JRPP No.	2012HCC019
DA No.	DA2012/549
Proposal	Demolition of structures and erection of a commercial/residential building including hotel and basement car park to be completed in two stages and stratum subdivision of car park
Property	Lot: 5 DP: 1145847 & Lot: 4 DP: 1029006 1 KING STREET NEWCASTLE
Applicant	Kred Pty Ltd
Report By	The City of Newcastle Council

Supplementary Assessment Report and Recommendation

Figure 1 - Proposed Site Plan with Concept Plan MP05_0062 building envelopes overlain.

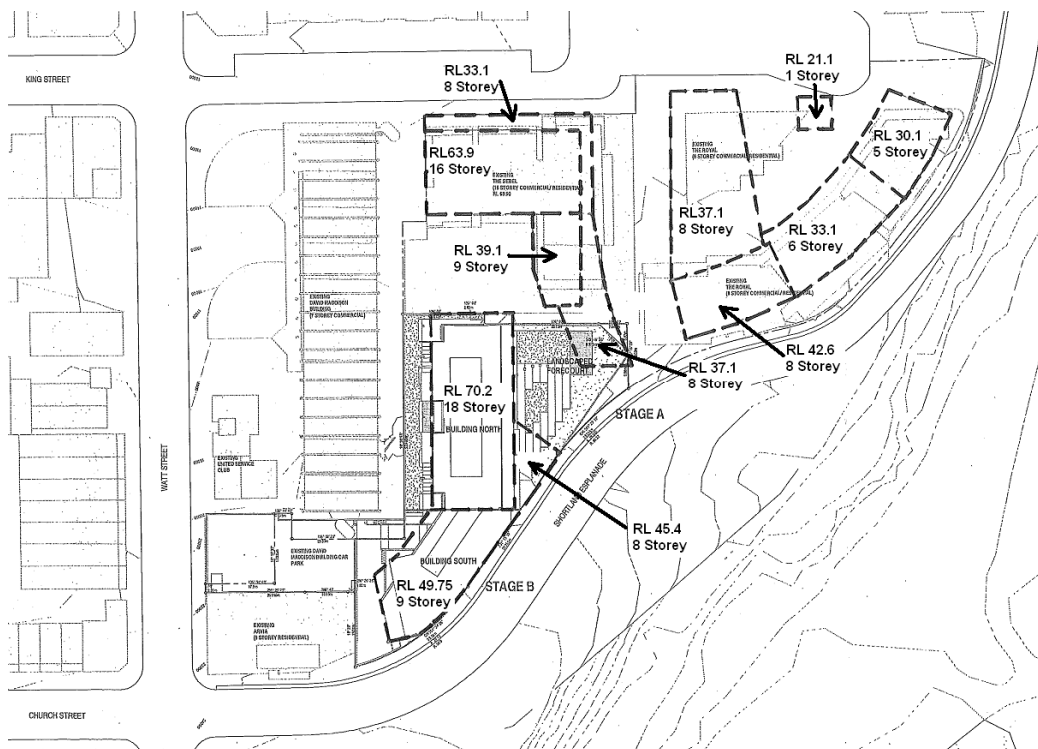
As can be seen the highest part of the Car Park Level falls primarily within the envelope nominated at 8 Storeys/RL37.1. It is apparent that the Concept Plan did envisage that there could be built form within this section of the site. The area of the Car Park Level that sits above street level and outside the eight storey envelope is approximately 170m² in area. This represents approximately 1% of the entire developments GFA. Such a minor variation could not reasonably be considered to result in a development that was not generally consistent with the building envelopes of the Concept Plan.

The approved Concept Plan envelope map does not provide any guidance on the areas between the envelopes. A thorough review of all approved documentation under the Concept Plan has been undertaken. The Site Design Principles as approved under the Concept Plan are silent on the matter of the treatment of the areas between the building envelopes. The Preferred Project Report dated 24 November 2006 (as referenced in the Concept Plan approved documentation) proposed the following heights (**Figure 2**).

In summary the 'forecourt' area is considered to be consistent with the objectives of the Concept Plan to improve pedestrian amenity of, and achieve level open space adjacent to, Shortland Esplanade. The elevated nature of the forecourt area, at the eastern end, is a product of the sloping nature of Shortland Esplanade. It is considered that to utilise underneath the forecourt area for car parking and hospitality (i.e. the 'Car Park Level') is not inconsistent with the Concept Plan. In any regards the higher sections of this level (at the eastern end) sit generally within a building envelope nominated as up to eight storeys in height. Accordingly the 'Car Park Level' is considered to be generally consistent with the Concept Plan, including the building envelopes and therefore can be permitted.

Figure 2 – Proposed building heights – Preferred Project Report, dated 24 November 2006 (Concept Plan MP05_0062)

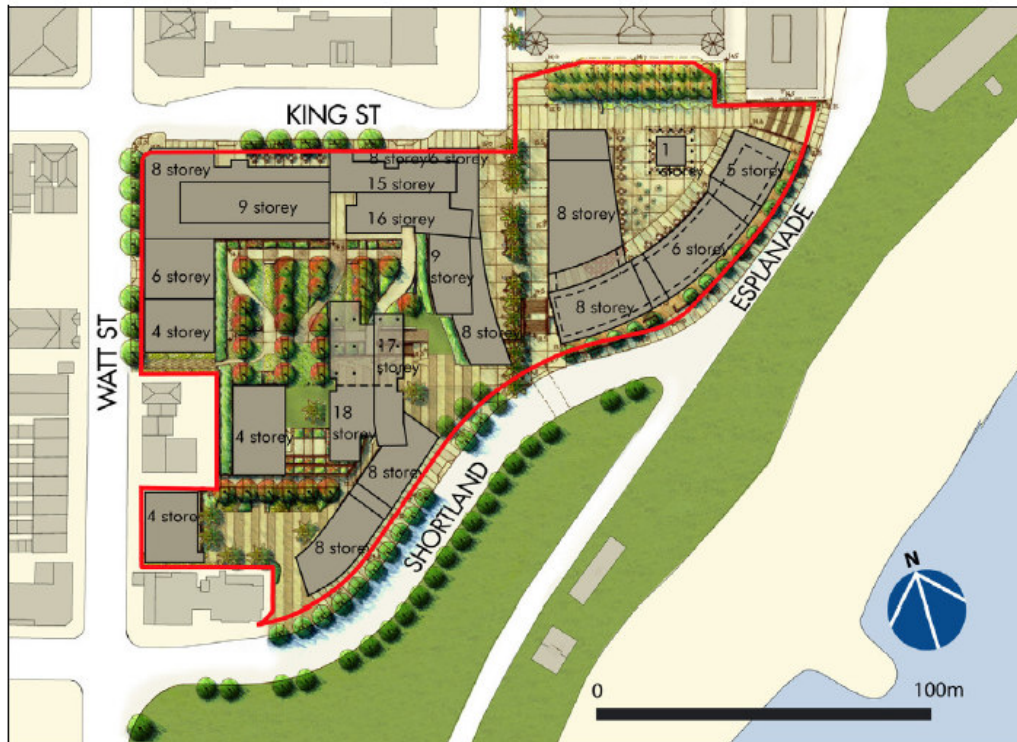
The proposed height map (Figure 2), while generally superseded by the Concept Plan building envelope map, does provide some further clarity in terms of the areas between the envelopes. It indicates open space between the envelopes and also has a level of RL18.5 nominated at the north-west corner of the open space area within which the forecourt is proposed. This level is similar to Shortland Esplanade at the eastern end of the site which would imply that a level open space area adjacent to the Shortland Esplanade frontage is desired. It is agreed that useable level open space between the higher building footprints is desirable and the proposed development is considered consistent in this regard. Such a level also confirms that under the Concept Plan it was envisaged that the sections of the site currently below Shortland Esplanade can be built within, even outside the nominated building envelopes. This is also supported by the description of the Concept Plan which included 'basement car parking'.

However, the nominated level at RL18.5 on this map is not practically achievable. Such a level in this open space area would require a cut of approximately 4m below Shortland Esplanade at the western side. Due to slope it is simply not possible to achieve a continuous level open space area along the Shortland Esplanade frontage without either a cut or fill. An objective of the Concept Plan (outlined within the

Preferred Project Report, dated 24 November 2006) was to improve the pedestrian amenity of Shortland Esplanade. It would be highly undesirable to the activation of Shortland Esplanade to locate the open space area up to 4m below the footpath level. It would also raise ongoing safety concerns for Council with safety railing required to prevent pedestrian falling into the site.

The proposed development that has a progressively elevated open space area terminating in the habitable 'hospitality area' underneath (at the eastern end) is considered a much better resolved outcome, enabling a more active street edge. It is therefore considered that the forecourt area of the proposed development has achieved the objective of the Concept Plan and that the habitable area underneath is a positive design outcome for the site and public domain area.
